**Sub:** Request to regular approval of final CCU software ver 2.06, TCU software 2.25 & ACU2.07 package as per below mentioned details to upload in all IGBT based propulsion system 6000HP (Leroy & Lutze IO module) WAG-9 / WAP-7 fitted locomotives.

Distribution:  To all Team Leads and CCU System Engineers.	Document No.	WAG9-9K-EN5-RLN-12
	Issue Date.	10-Jun-2024
	Format	Total Pages : 5 + Enclosures: 2 Document initiated by : SATYA PRAKASH. R Initiating Department : RC-IN SMO RS EN 5 This supersedes : WAG9-9K-EN2-RLN-11

Release of CCU & TCU software.

#### a. Cause-1 PANTO BOUNCING : -

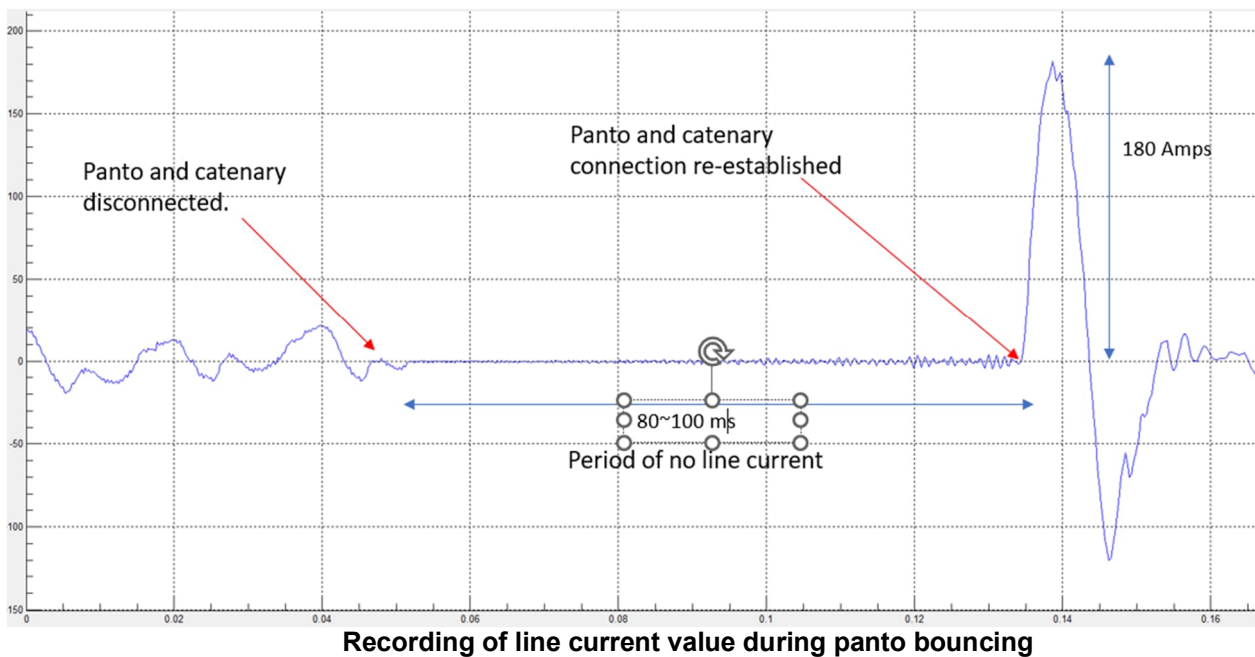
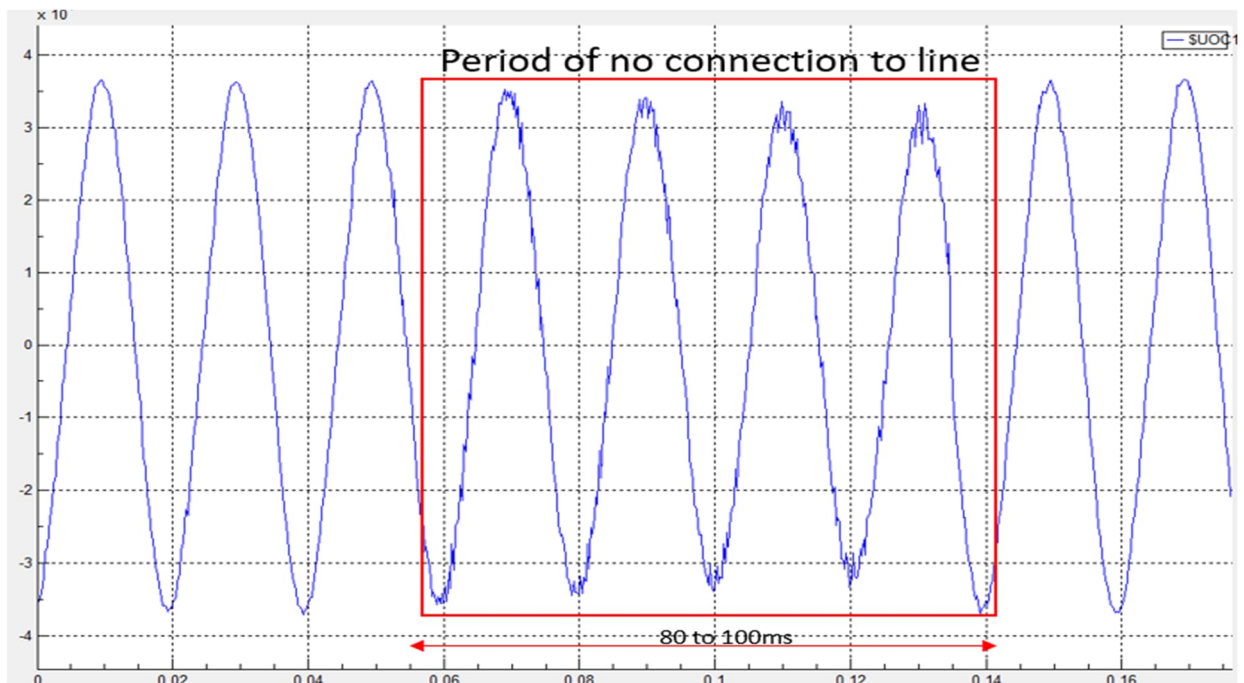
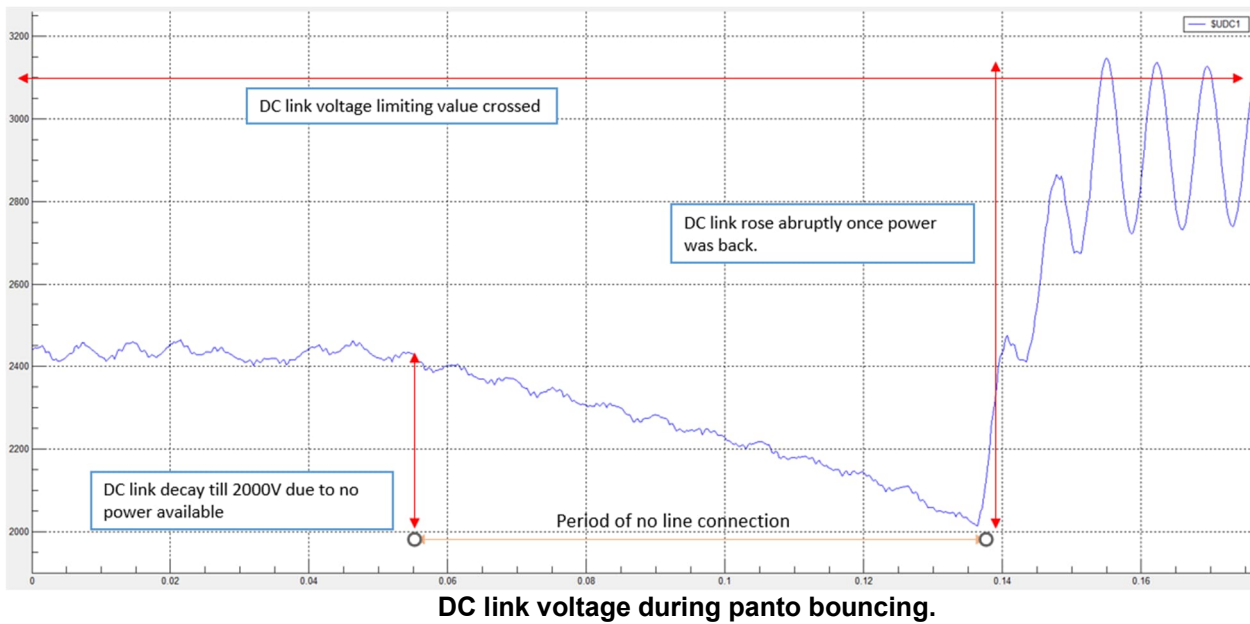
Field trails were conducted in WAP-7 Locomotive at speed range of 0-130 Km/h  
Above mentioned fault codes were recorded by TCU at high speed, i.e. speed greater than 60 Km/h.

Based on fault code 81 reading of the 4QC, it was observed that there was incidence of panto bouncing during which line current goes to zero. This panto bouncing period lasts around 80 to 100 ms at high-speed operation.

When the contact between panto and Catenary disconnects, DC link voltage drops to approx. 2000V which increases the demand for more current. When the contact between panto and catenary is re-established, high inrush of line current is observed.

Peak of this line current can be seen in graph which is approximately 180 A. Thus, causing sudden rise in DC link voltage above 3100 Vdc.

This condition trigger's fault code 81 which signifies DC link overshoot above 3100 Vdc which results in opening of VCB.

Here, the period of line connection and disconnection is marked and observed time is around 80 to 100 ms. During this period, line current goes to 0.

The voltage shown in the red box is not the actual line voltage but the apparent line voltage due to the continuous pulsing of 4QC.

It can be seen from above graph, once the connection between panto and catenary was re-established, there is sudden rise in the DC link voltage observed.

- a) Voltage retention feature has been activated in both TCU and CCU software's. Voltage retention feature will be activated only when locomotive speed is above 30Km/hr and will be deactivated if the speed of locomotive is below 25Km/hr.
- b) PWI closed loop control error detection is now improved (DC 145) and related number of short pulse blockings is now removed.
- c) 4QC control is improved by Parameter by Smoothing time adjusted (10 ms => 0 ms) resulting in faster DC-link Control.

## b. Cause-2 Sudden Variation in Line Voltage :-

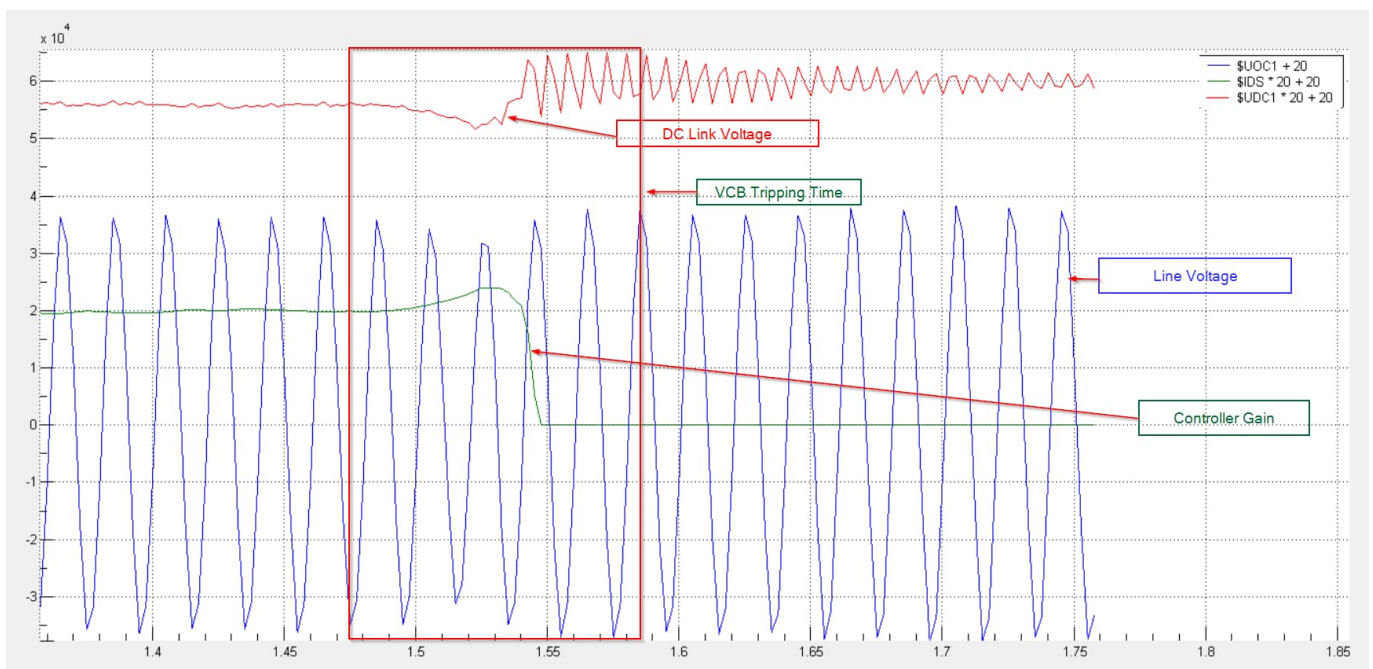
It can be seen from above graph, that line voltage variation which was causing increase in line current and tripping VCB and causing DC-Link voltage over shooting.

## c. Cause-3 asynchronization of PWI's & Motors : -

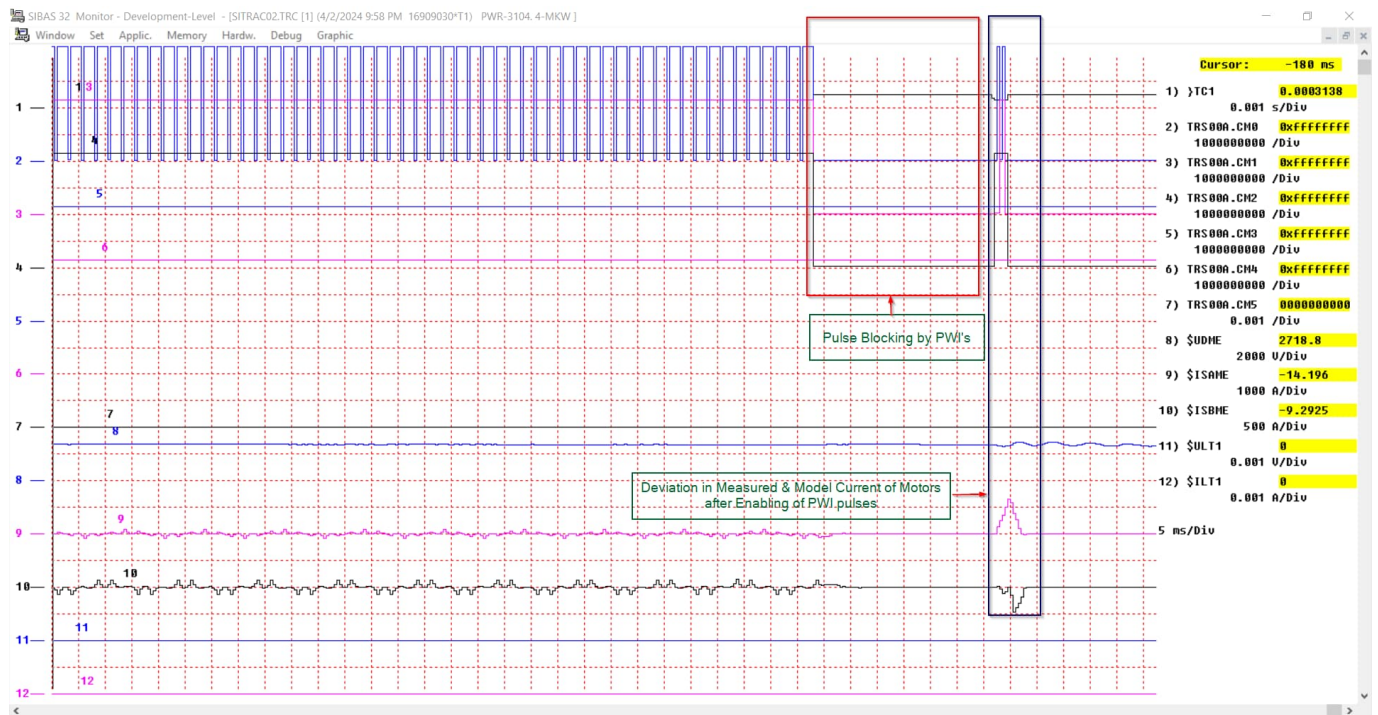
As shown in the above figures shows Pulse blocking phenomena which is causing the synchronization of motors and PWI (Signals 9,10) in first picture. Also Pulse pattern deviation in of PWI's in signal no 31 in second picture.
